SUPPLEMENT B - ADDENDUM
 SLOPE STABILIZATION PLAN
 PORTAL AREAS - BLACK HAWK MINE
 SUMMIT COUNTY, UTAH

This document is an addendum to the SLOPE STABILIZATION PLAN (SUPPLEMENT B) of the mining and reclamation plan for the Black Hawk Mine, Summit County, Utah. SUPPLEMENT B was submitted by Utah Coal and Energy Inc. (U.C.&E.) to the Oil, Gas and Mining Board, Division of Oil, Gas and Mining, Department of Natural Resources, State of Utah (referred to hereinafter as the Board) in November, 1980. After reviewing SUPPLEMENT B the Board asked Mr. C. Cafarelli, President, U.C.&E. for certain additional information relative to the proposed water diversion above the portal area. This addendum addresses the water diversion above the portal areas and seeks to provide specific point-by-point information and answers to the enumerated items in paragraph 2 of the correspondence, Board to U.C.&E., dated February 11, 1981.

SPECIFIC INFORMATION—WATER DIVERSION

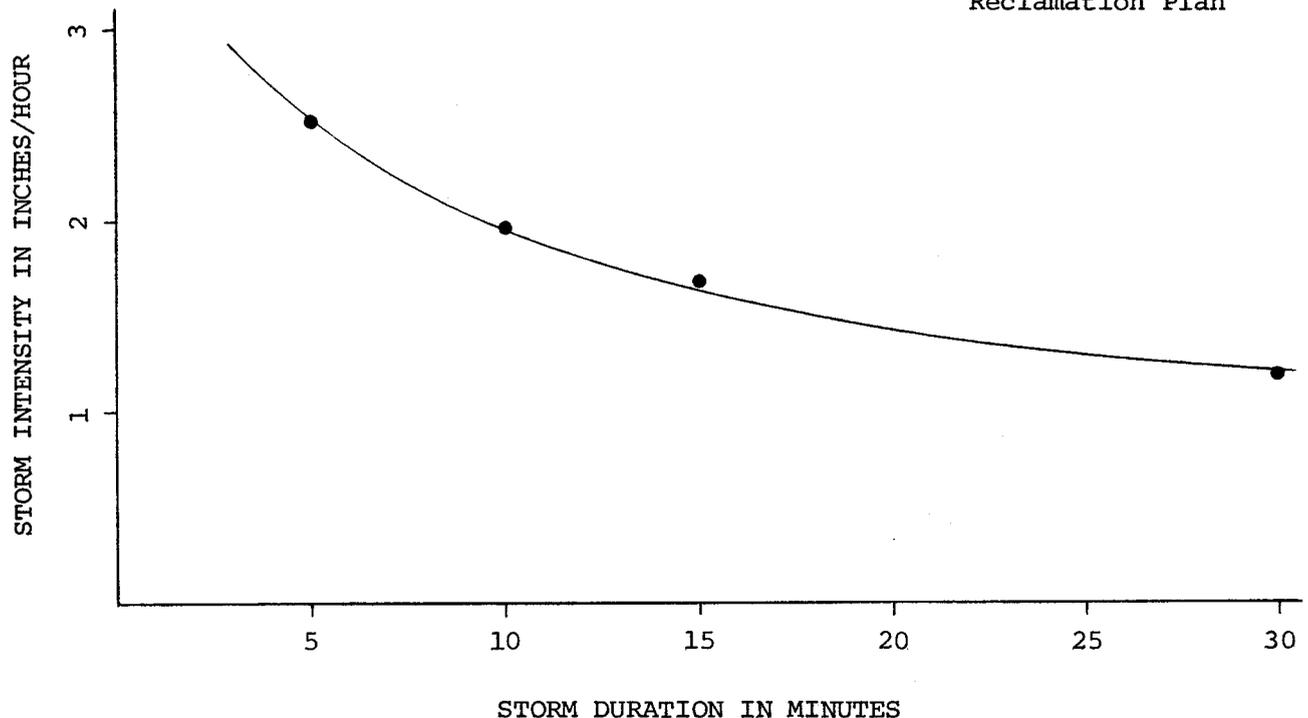
*question
this value
as possibly a little
low*
